Landscape Mitigation Plan

Contract no. KL/2014/03

Kai Tak Development – Stage 3 Infrastructure Works for
Developments at the Southern Part of the Former Runway

Contract No. KL/2014/03 - Kai Tak Development - Stage 3 Infrastructure Works for
Developments at the Southern Part of the Former Runway
Submission of Landscape Mitigation Plan

Figure A1- Works Extent of Contract No. KL/2014/03 Under EP-337/2009

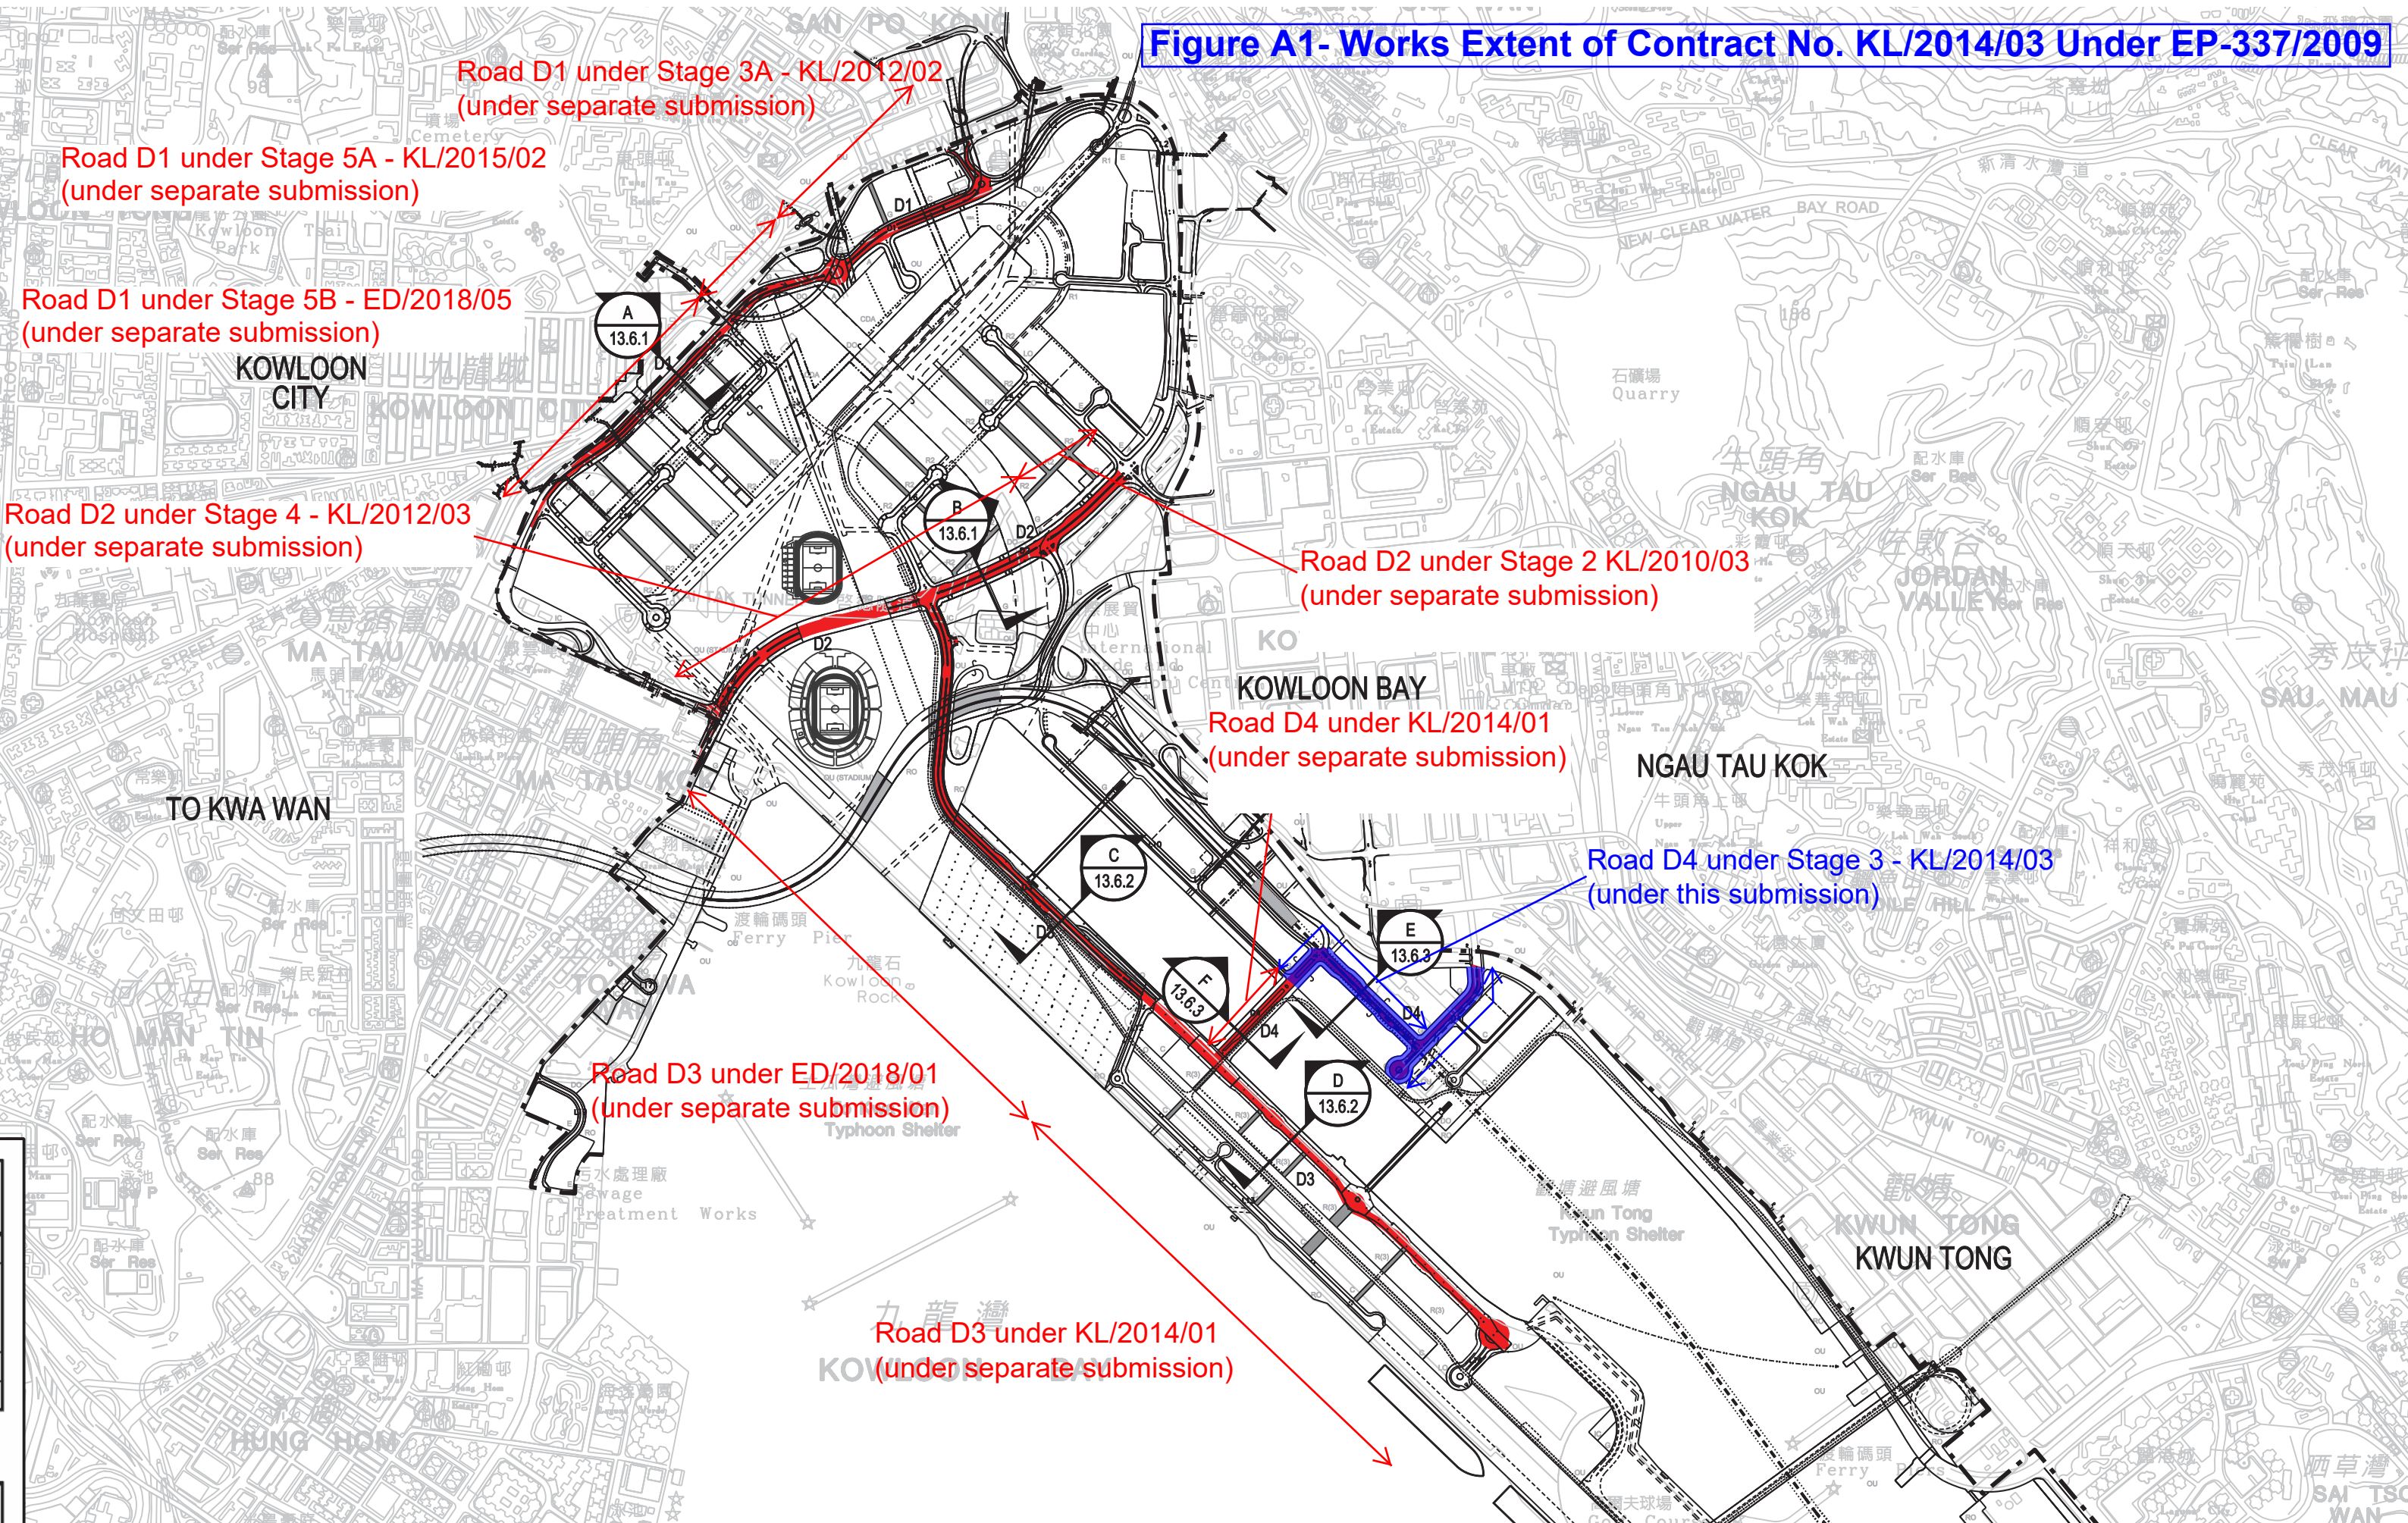
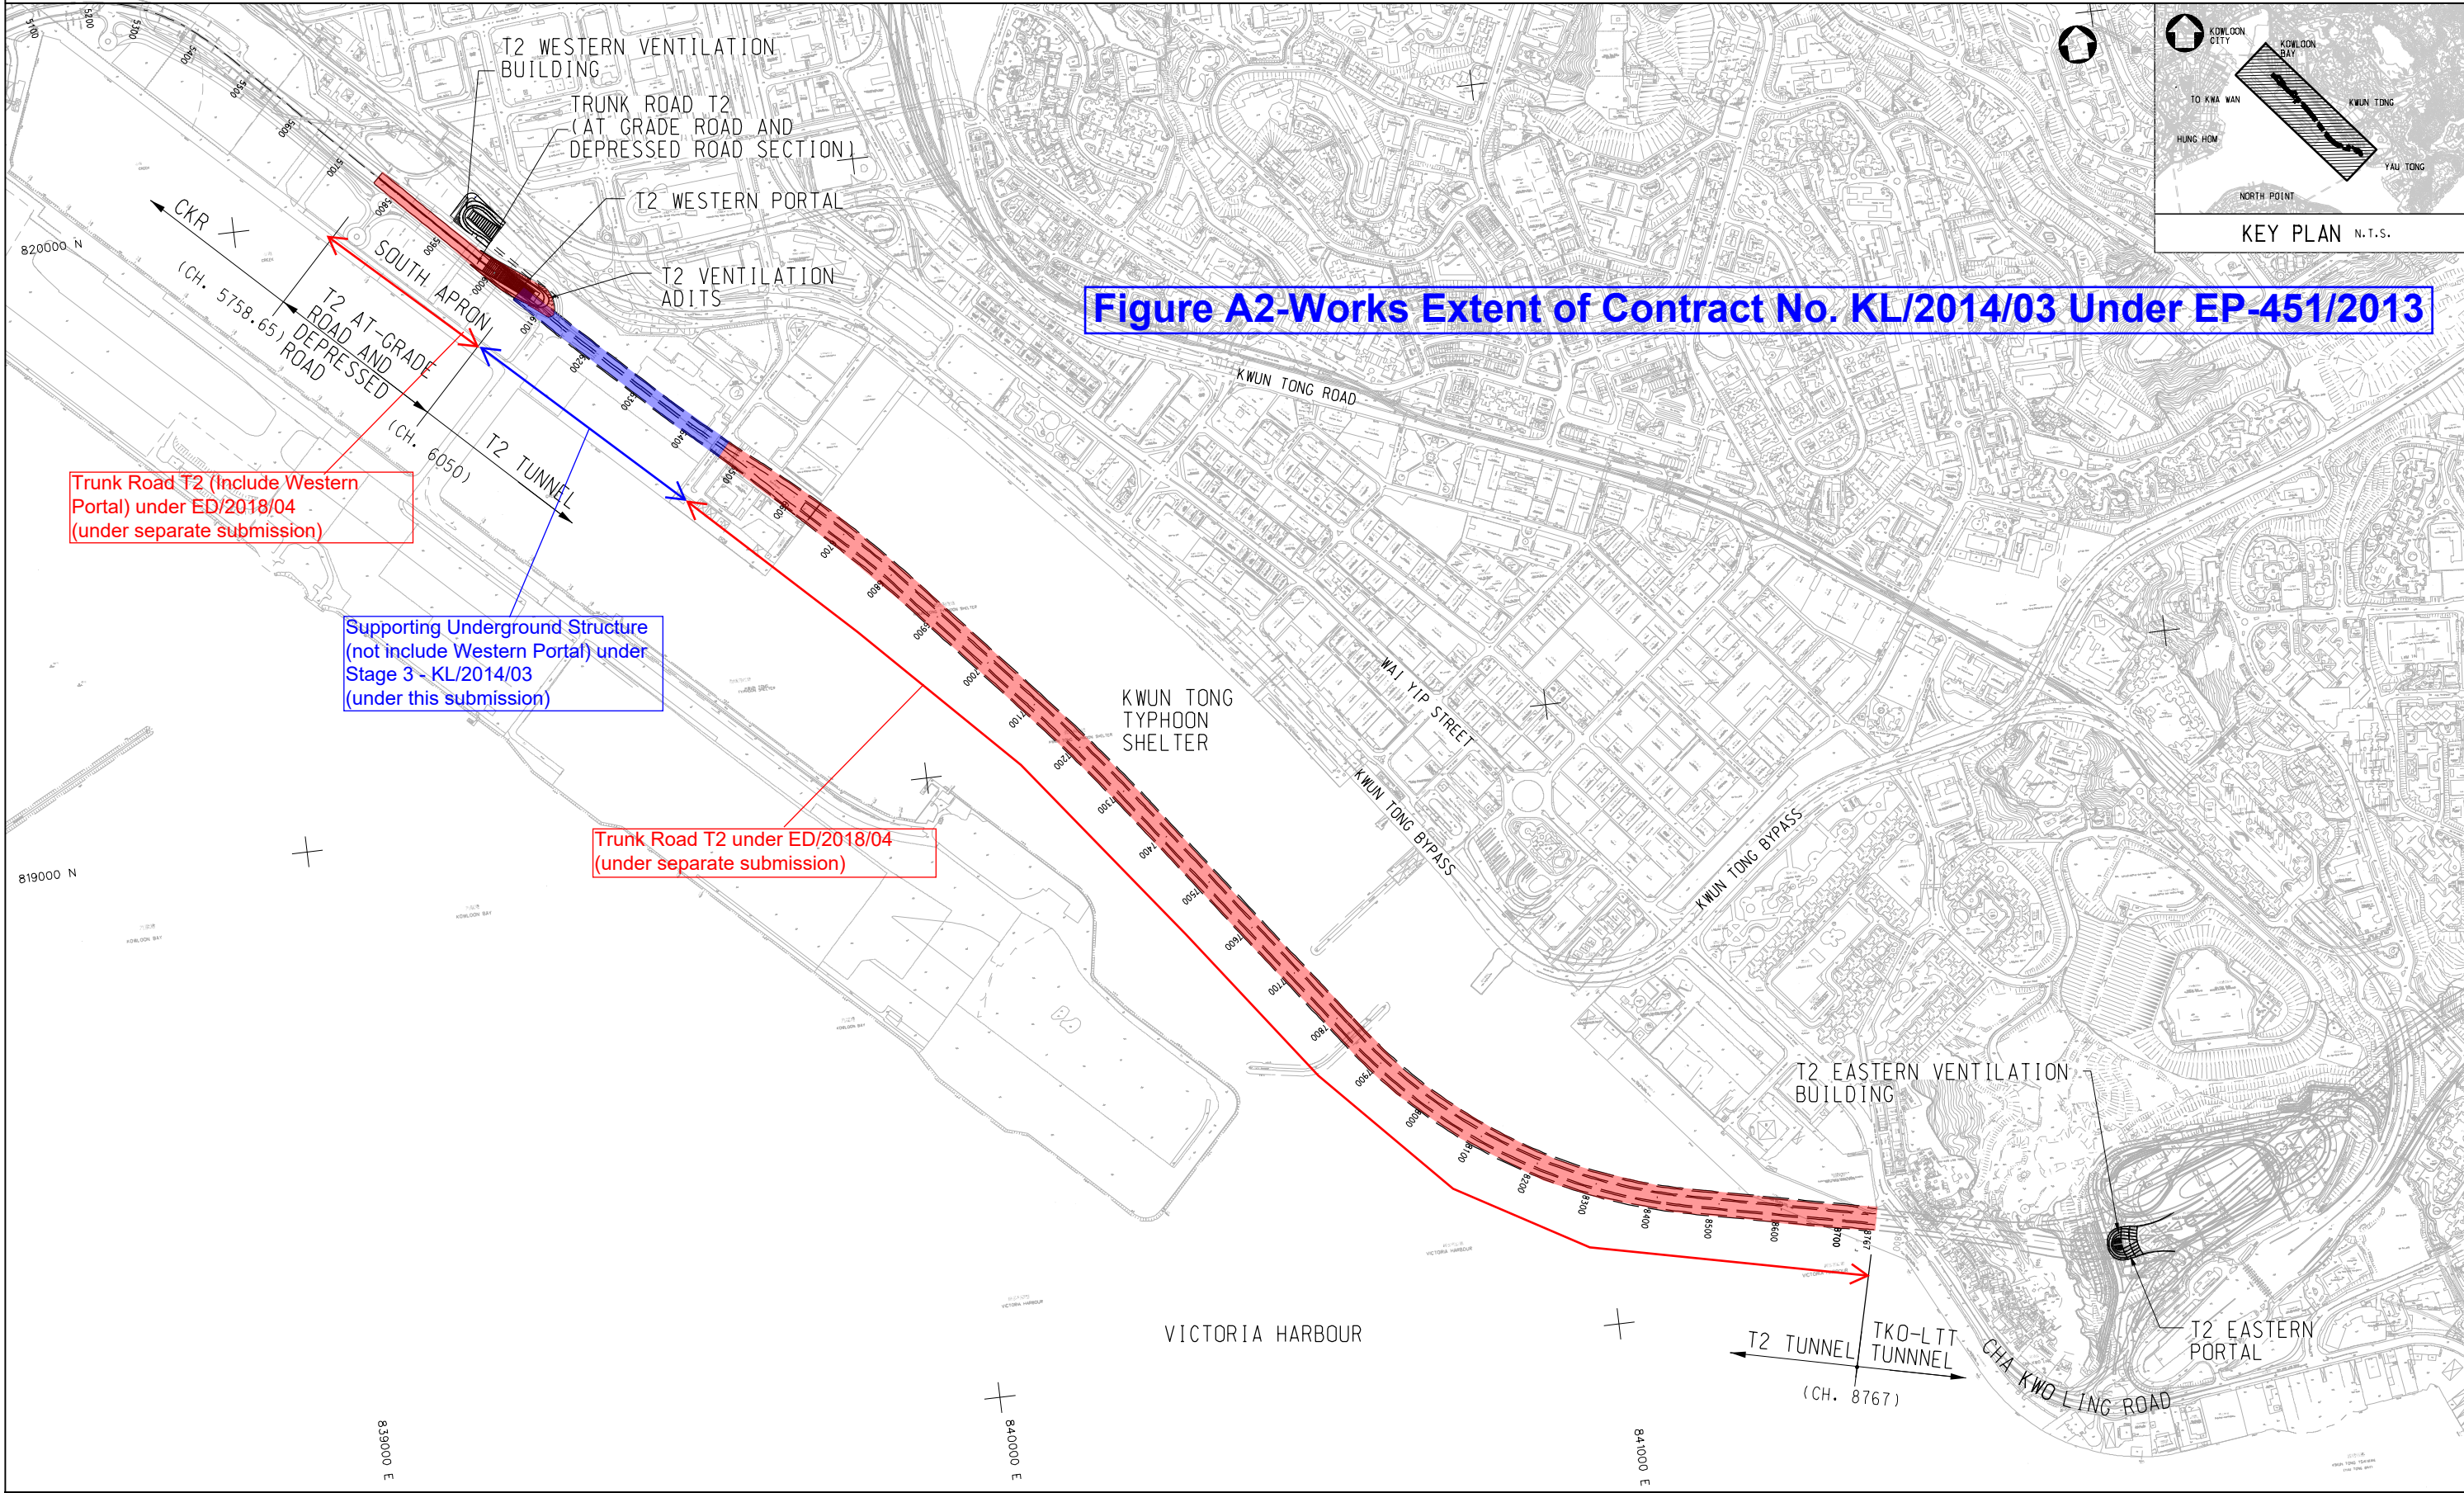
<u>General Comments</u>	
1.	It is understood that the submission covers part of Road D4 which should be covered by Permit No. EP-337/2009 (Register No. AEIAR-130/2009) and a small portion of Trunk Road T2 which should be covered by Permit No. EP-451/2013 (Register No. AEIAR-174/2013). The extent of the corresponding EP covered area should be clearly indicated on plan for reference.	Please find the extent of the works for part of Road D4, covered under Permit No. EP-337/2009 (Register No. AEIAR-130/2009) and construction of a small portion of Trunk Road T2 (Supporting Underground Structure), covered under Permit No. EP-451/2013 (Register No. AEIAR-174/2013) marked on plans in Appendix A - Figures A1 and A2.

13.	For the current EP submission. no clear extent and supporting information for the part of Trunk Road T2 is indicated. The extent of work covering by this EP should be clearly indicated on plans with supporting information for our further review.	The extent of works covering by this EP submission is shown in Appendix A - Figures A1 and A2 for your information.
